United States Nuclear Regulatory Commission
Attachment IX to Serial: RNP-RA/97-0123
(930 Pages)

H. B. ROBINSON STEAM ELECTRIC PLANT, UNIT NO. 2
TECHNICAL SPECIFICATIONS CHANGE REQUEST TO CONVERT TO THE
IMPROVED STANDARD TECHNICAL SPECIFICATIONS

SUPPLEMENT 4

SUPPLEMENT 4
CONVERSION PACKAGE SECTION 1.0
PAGE INSERTION INSTRUCTIONS

Figure 2.1.1-1 (page 1 of 1)
Reactor Core Safety Limits

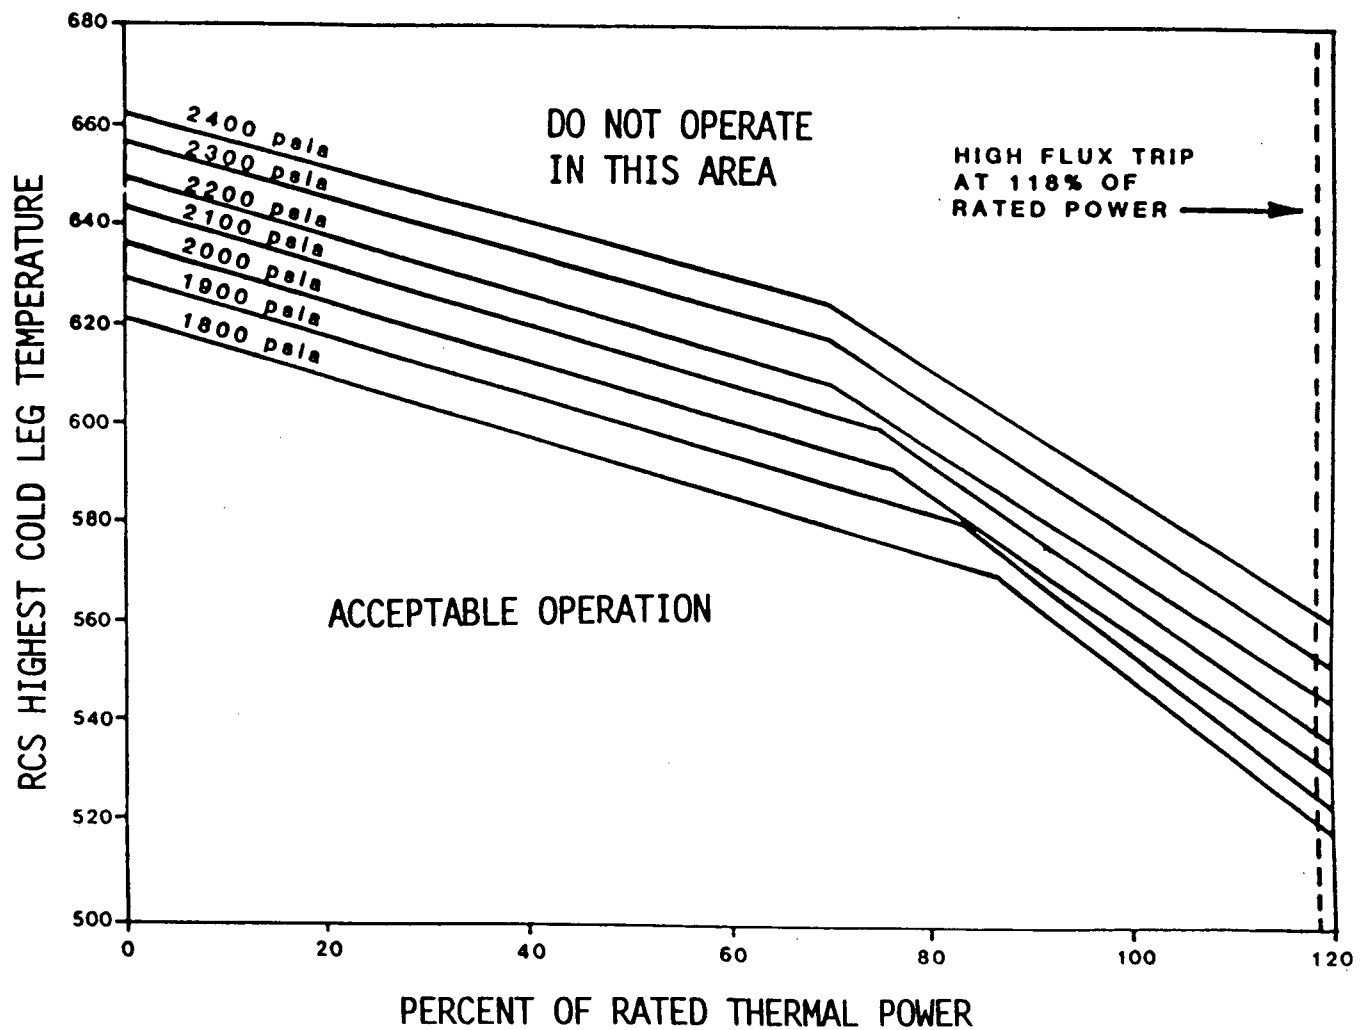
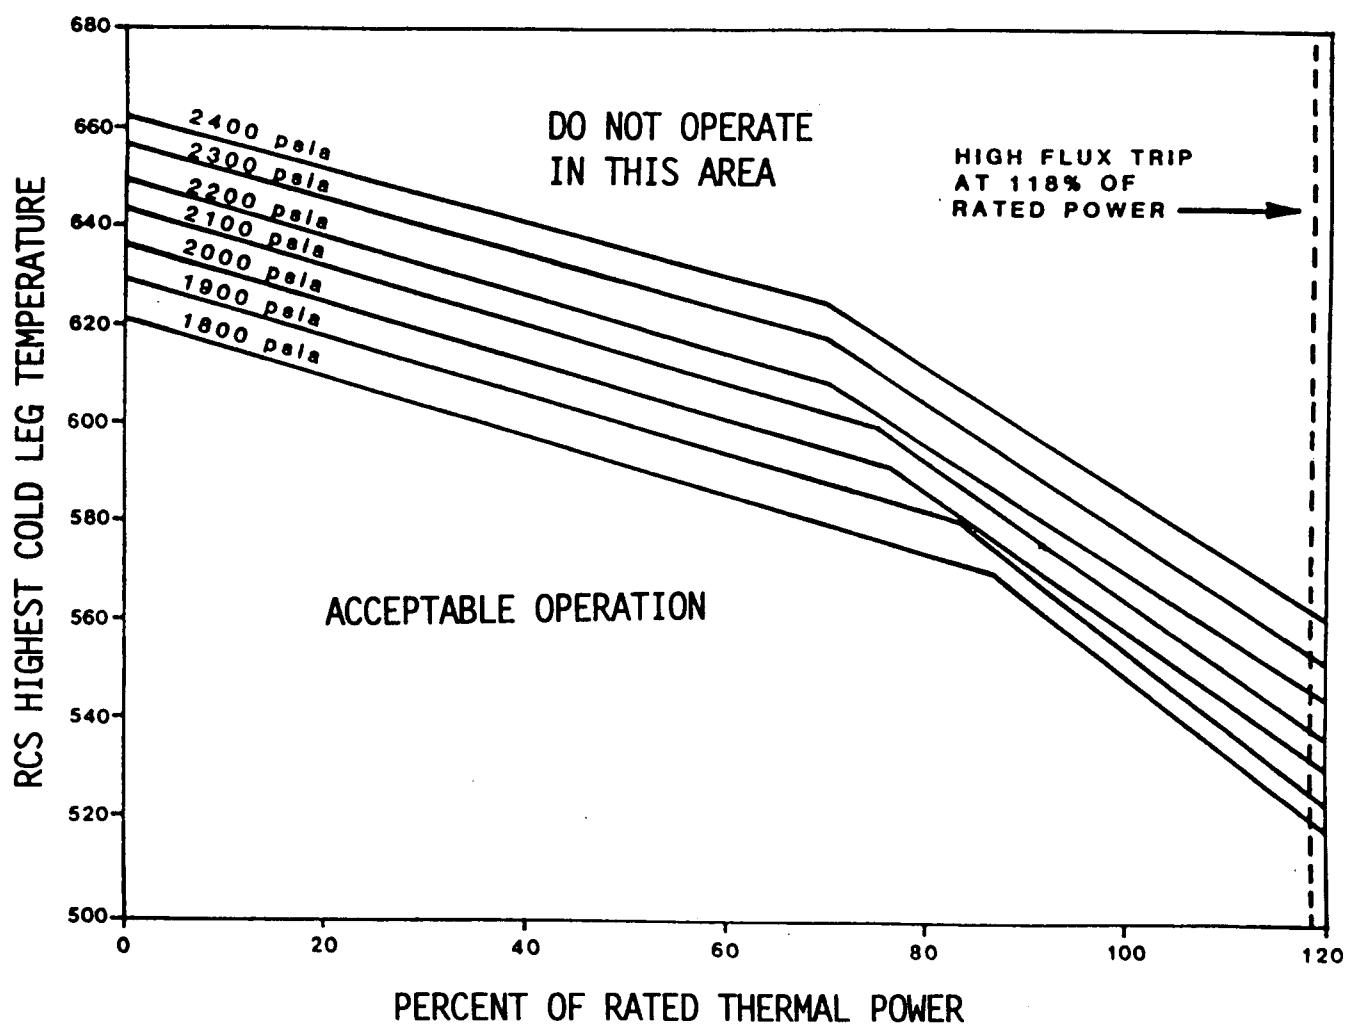
- A2 The CTS 2.1 reactor core SL Specification is not stated in terms of a specific point for the temperature measurement, however the referenced CTS Figure 2.1-1 is specified in terms of inlet (i.e., cold leg) temperature. The ITS specifically describes the SL in terms of the highest RCS cold leg temperature. The addition of the specific reference to "... highest cold leg temperature ..." is an administrative detail added for clarity.

- A3 CTS 2.1.d is not retained in the ITS. CTS 2.1.d provides administrative details defining when the SLs specified in Figure 2.1-1 and in CTS 2.1.b and 2.1.c are exceeded. This type of clarification is included in the comparable ITS Figure 2.1.1-1. See A4 for additional information. The additional administrative detail regarding CTS 2.1.b and 2.1.c merely reiterate that violating the specified limits is exceeding the SLs. This change is consistent with NUREG-1431.

- A4 CTS Figure 2.1-1 does not clearly define the regions of acceptable and unacceptable conditions. Administrative clarifications are included in ITS to delineate the appropriate regions on the figure. This change is consistent with NUREG-1431.

NOTE: BASED ON A MINIMUM RCS FLOW OF 97.3×10^6 lbm/hr
